Access Compliance Report Public Rights-of-Way (Pedestrian Signals)

Main Street: VALENCIA_AVE Cross Street: VALENCIA_AVE Location: NE

ADA ID: SGAT220218172734 Signal Type: One Push Button-Non APS Overall Compliance: No Severity Scores: BTN 1: 35 BTN 2: N/A No BTN: N/A

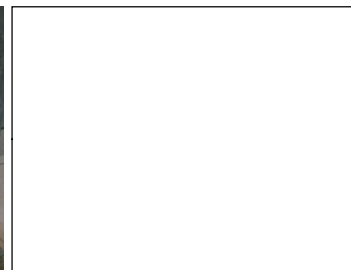
OC Std/PROW: R404.2, R403.4, MUTCD 4e.08

Possible Solutions: Replace Signal Push Button With APS Button. Remove and Replace Clear Space.
